WORCESTER TOWNSHIP PLANNING COMMISSION

PRELIMINARY / FINAL PLAN – HEALTH CARE NORTHEAST EXPANSION
COVER – INDEX SHEET
MEADOWOOD SENIOR LIVING
WORCESTER TOWNSHIP – MONTGOMERY COUNTY – PENNSYLVANIA
WOODROW & ASSOCIATES, INC.
MUNICIPAL / CIVIL CONSULTING ENGINEERS
1108 North Merkle Street, Suite 200
Pottsville, PA 17860
Phone: (717) 542-6648 Web: www.Woodrowinc.com

PRELIMINARY / FINAL PLAN - HEALTH CARE NORTHEAST EXPANSION
RECORD PLAN - OVERALL TRACT
MEADOWOOD SENIOR LIVING
WORCESTER TOWNSHIP - MONTGOMERY COUNTY - PENNSYLVANIA

PROFILE: EXISTING INLET D108 to INLET D106

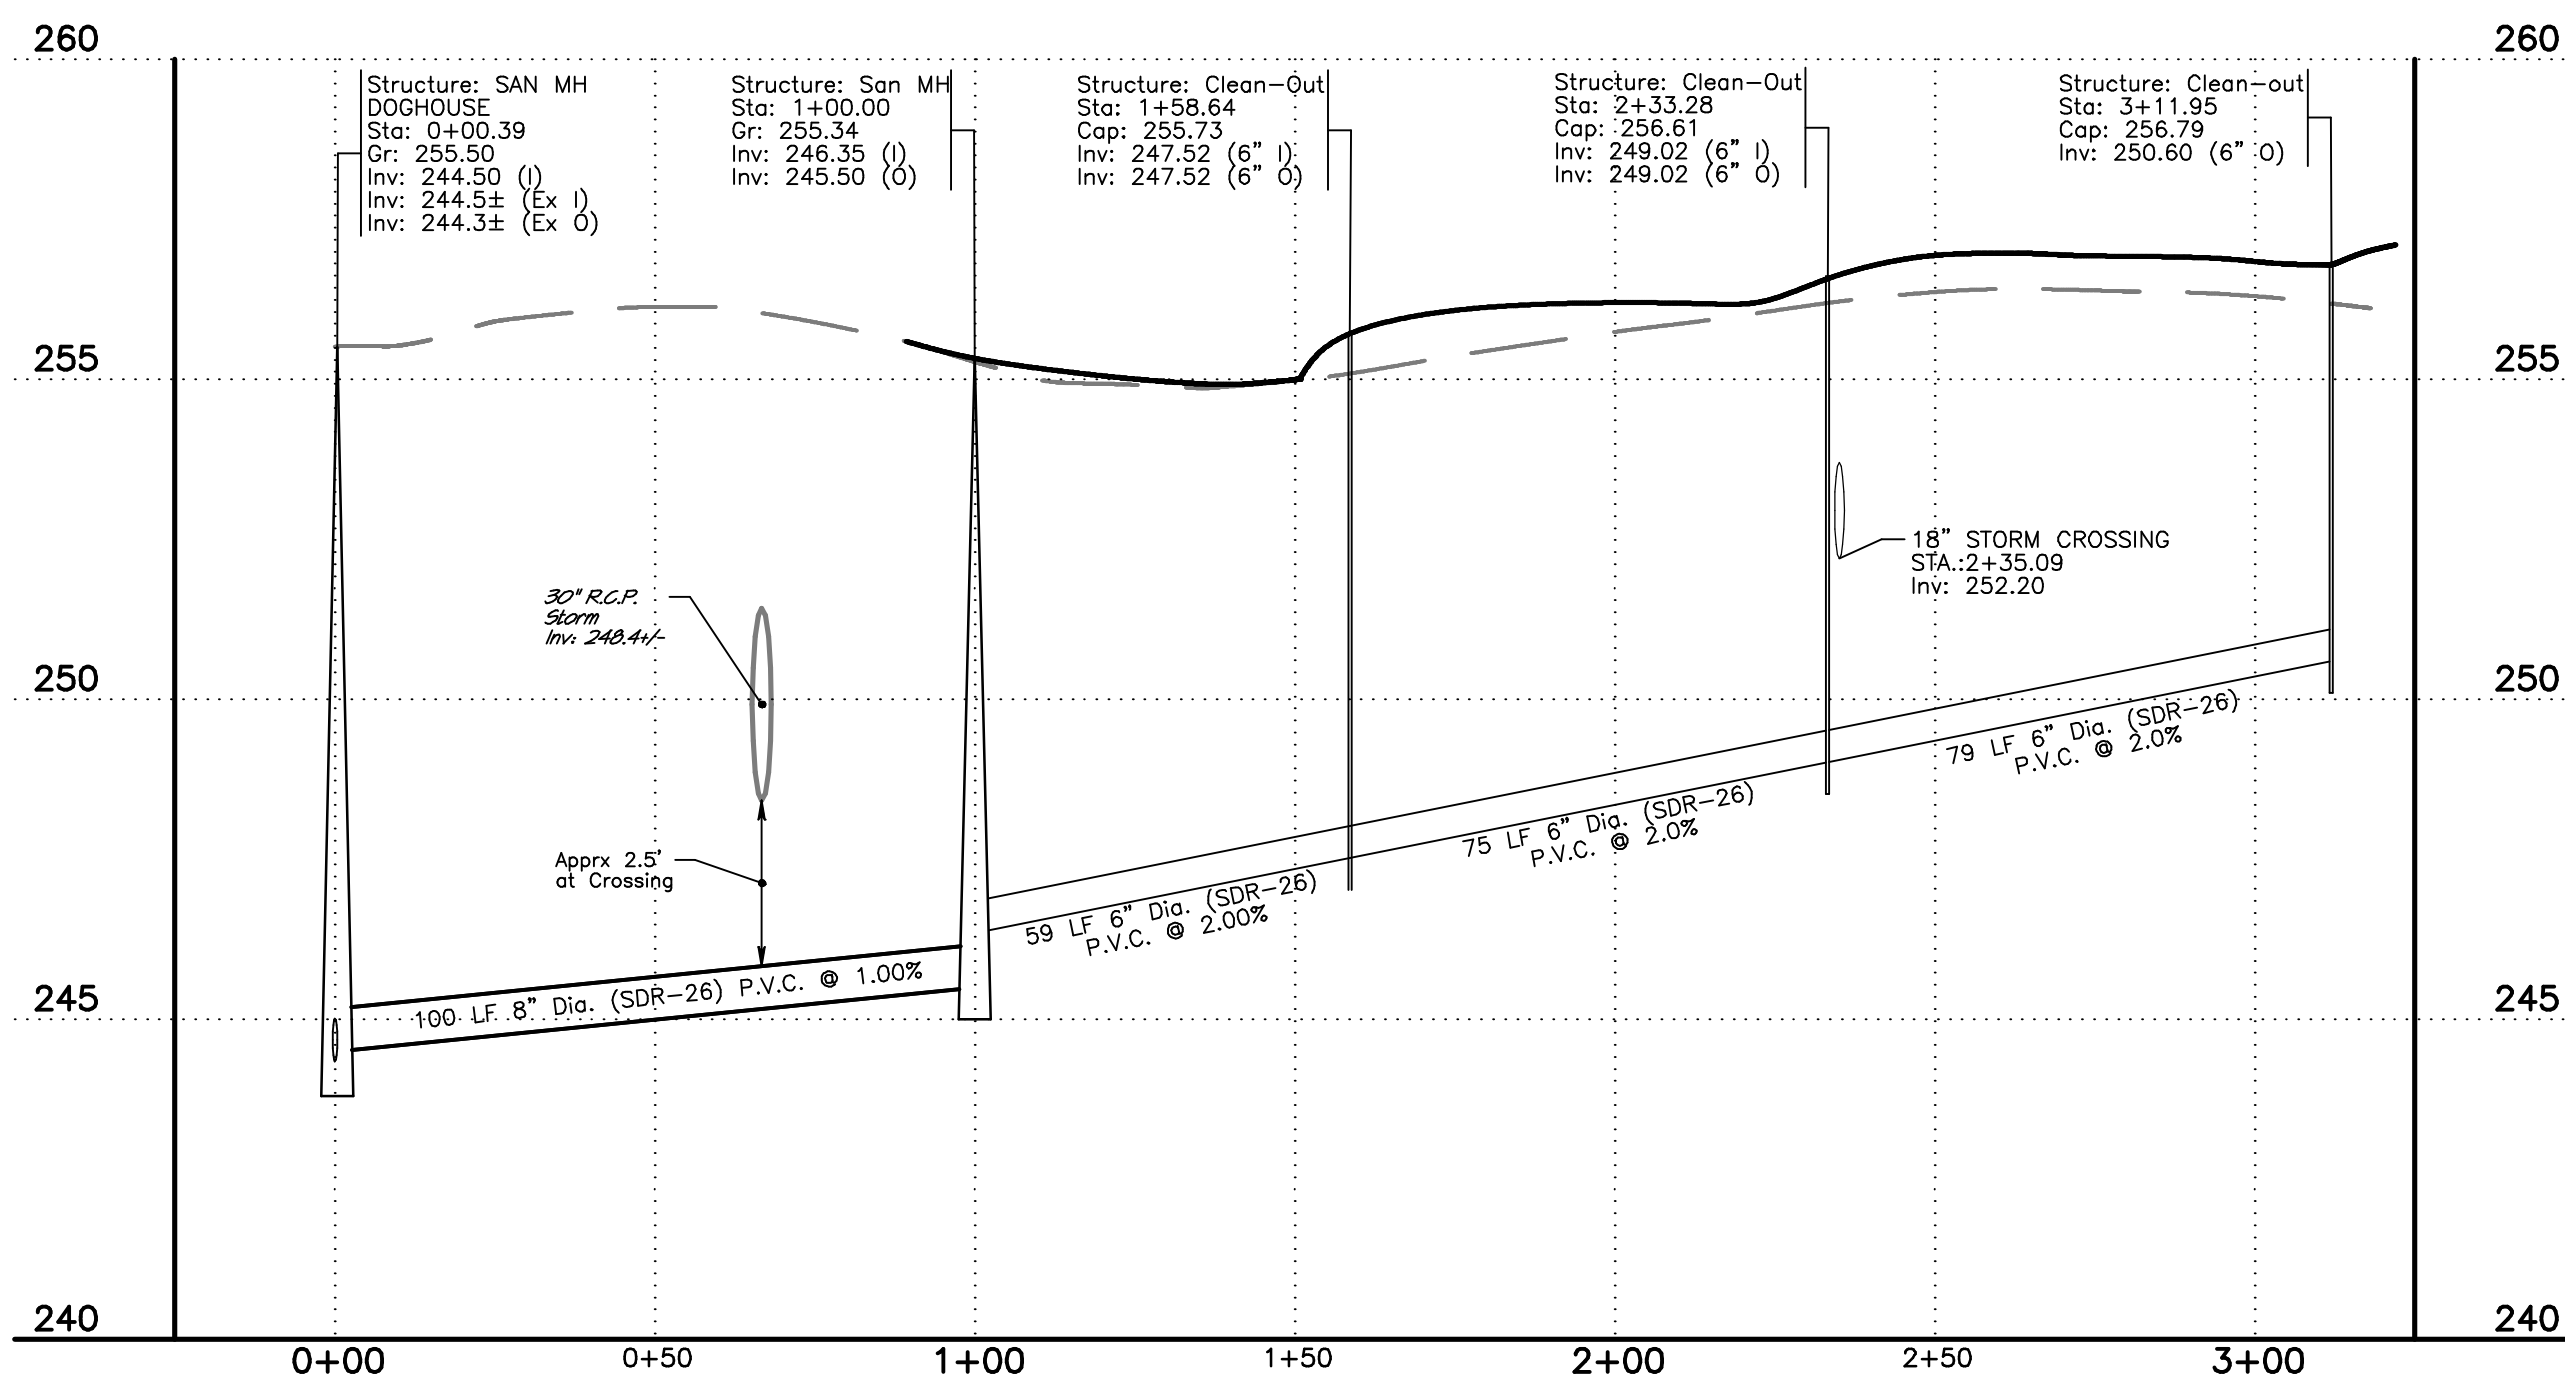
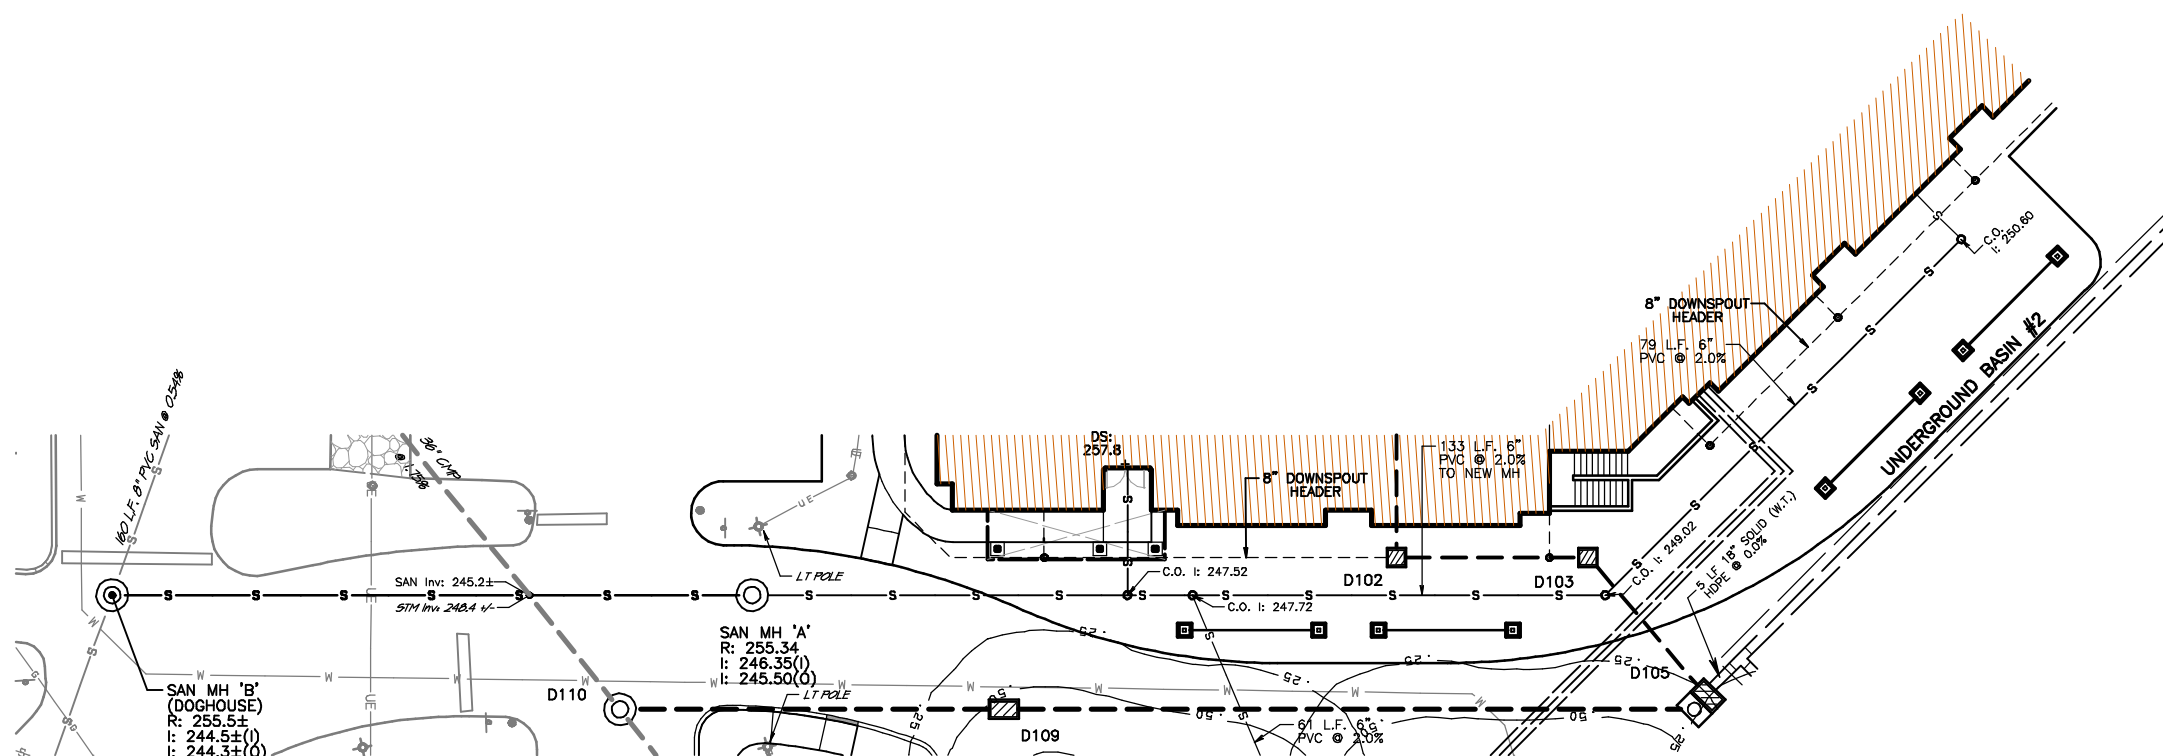
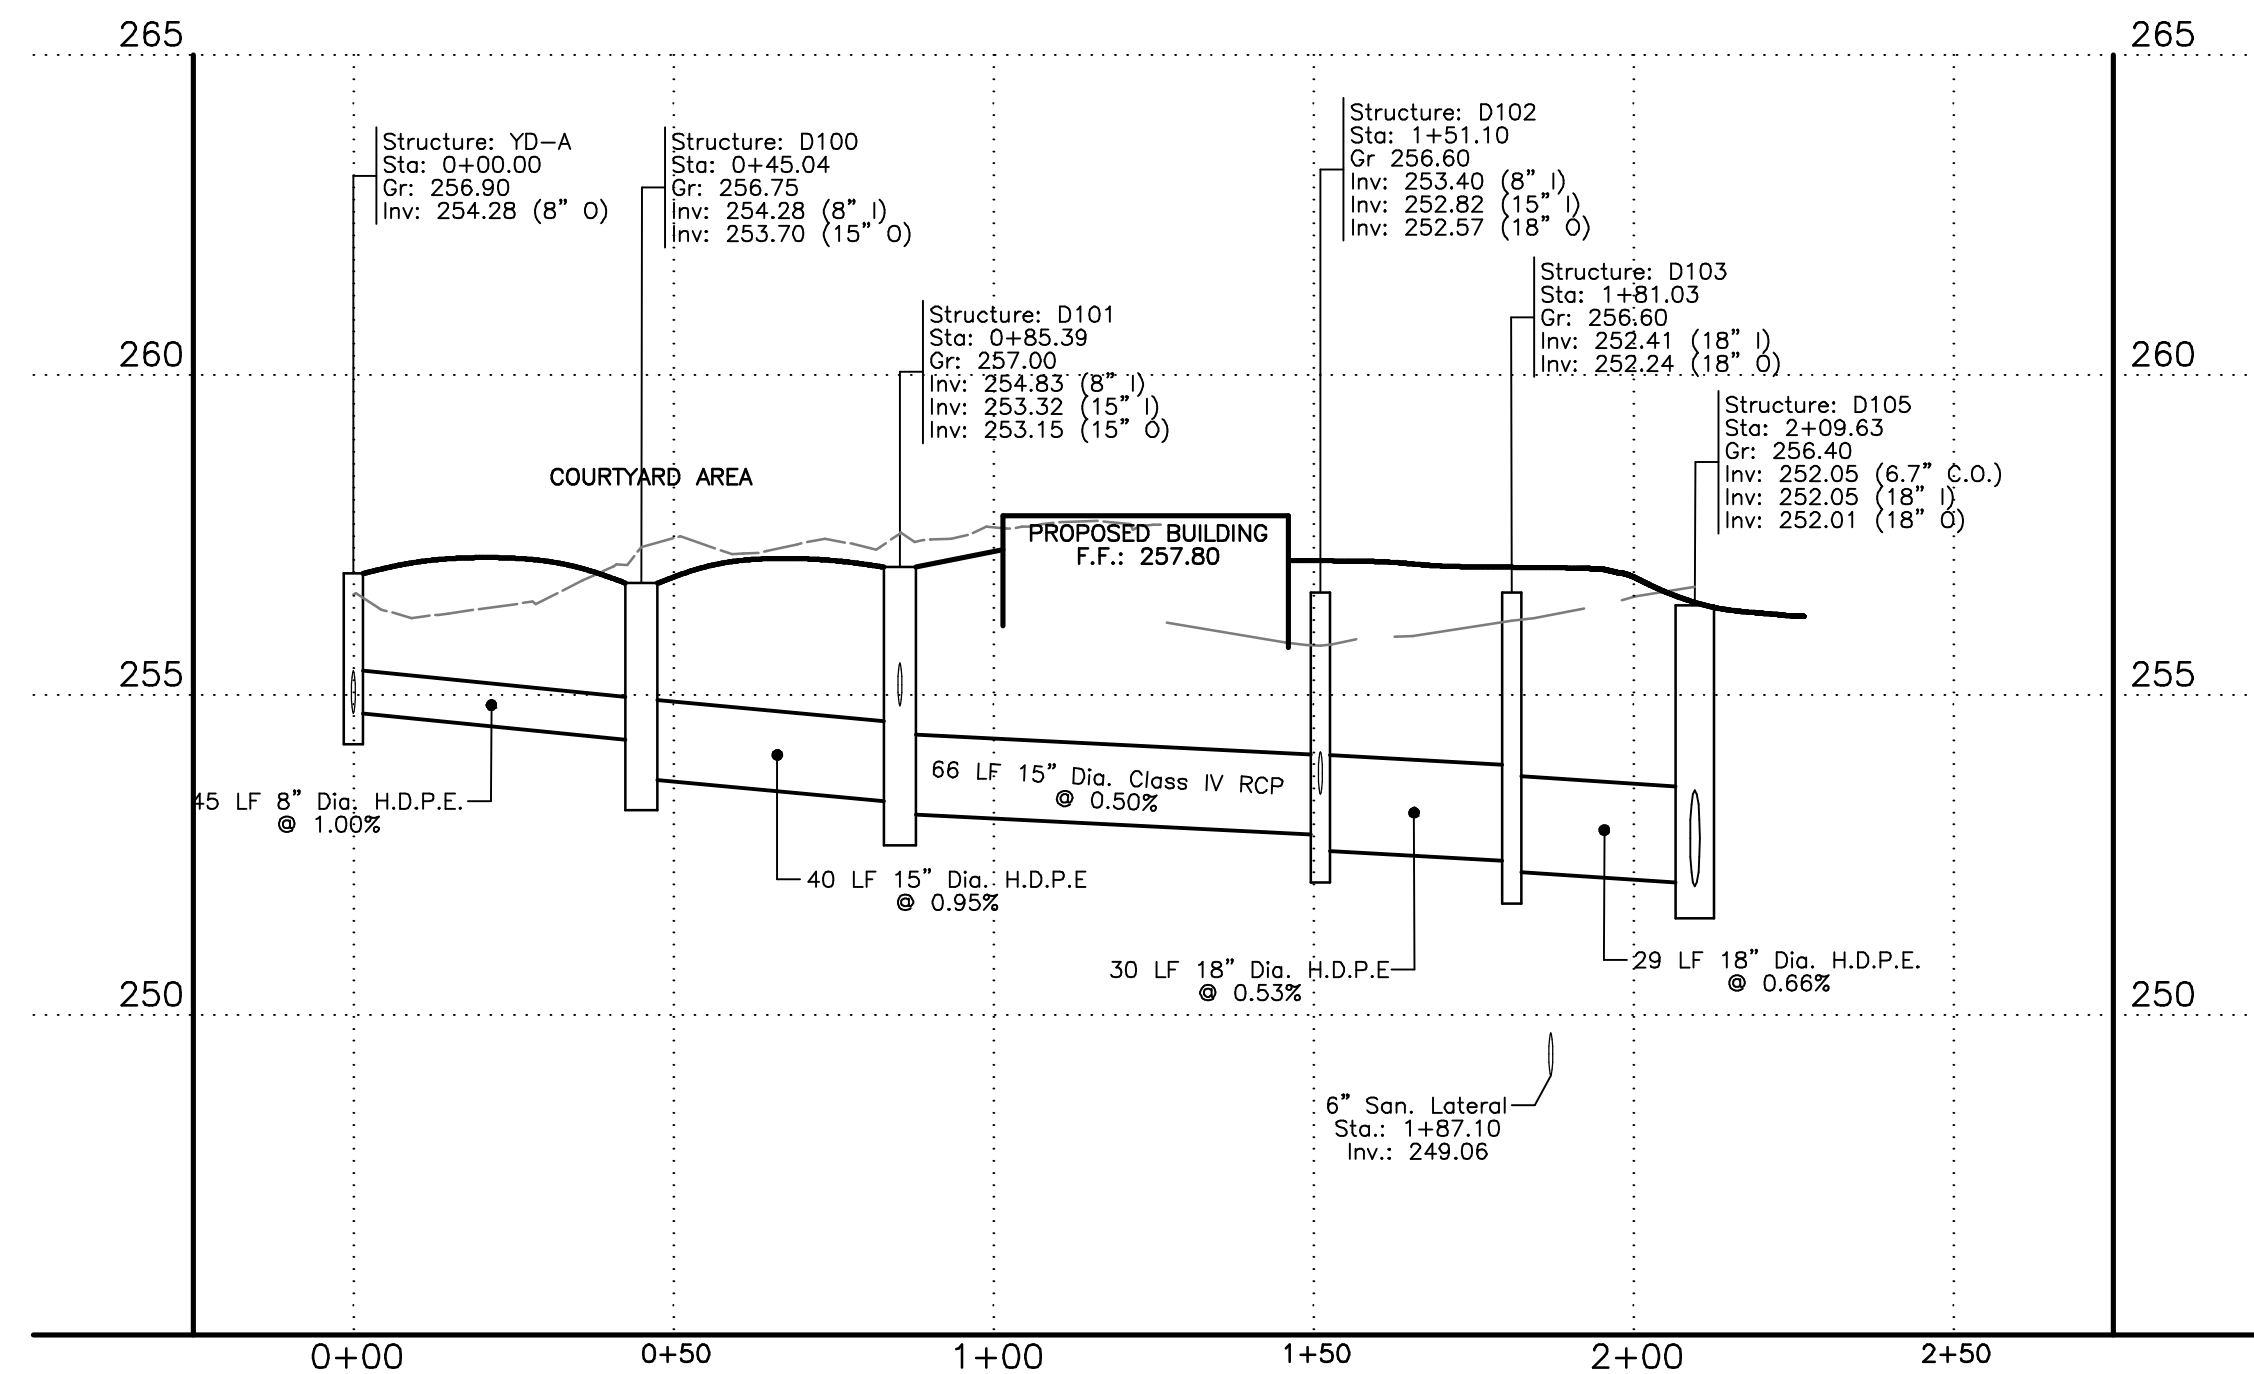
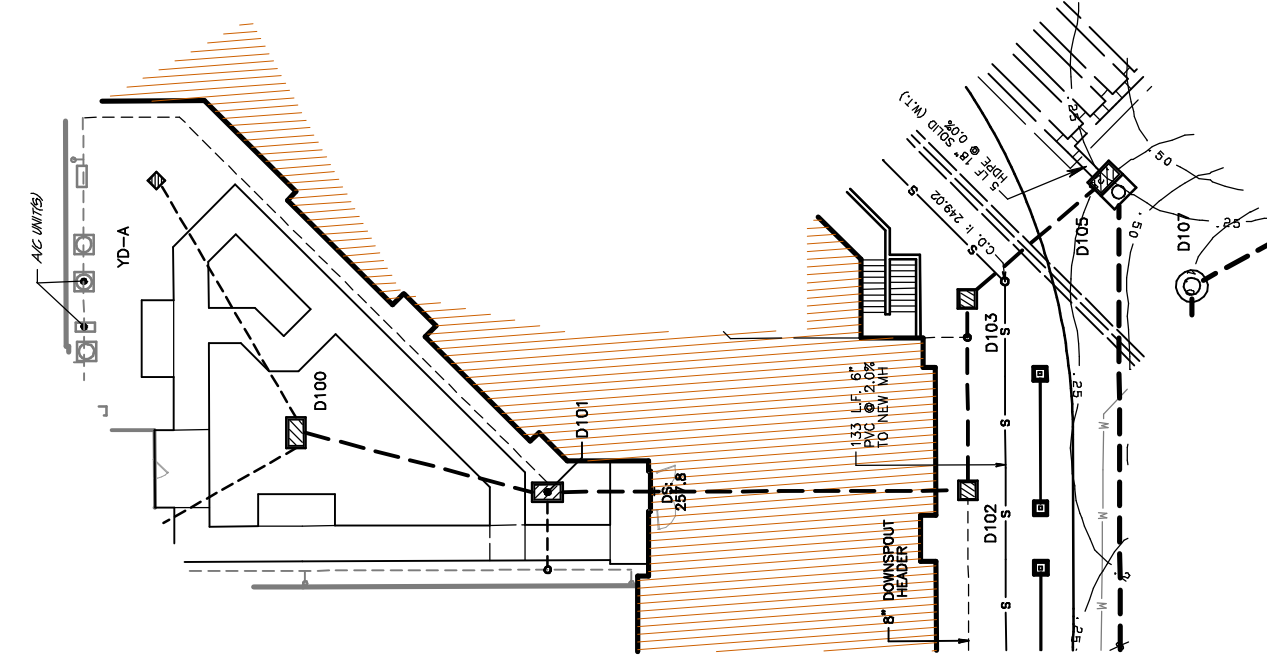
4. *On both Sheet 6 and Sheet 9, there is a missing invert for structure D104.*

5. *Sheet 6 has a rim elevation for Manhole D105 of 255.73 and Sheet 9 has a grate elevation of 255.66. The plans must be revised accordingly.*

14. Inlet D106 must be shown on the profiles on Sheet 9. (130-33.F.1)

1. The sanitary lateral profile on Sheet 9 only shows one "proposed" segment of PVC; however, it is our understanding that all portions shown in the profile will be newly installed. The labeling and line weights should be adjusted accordingly.
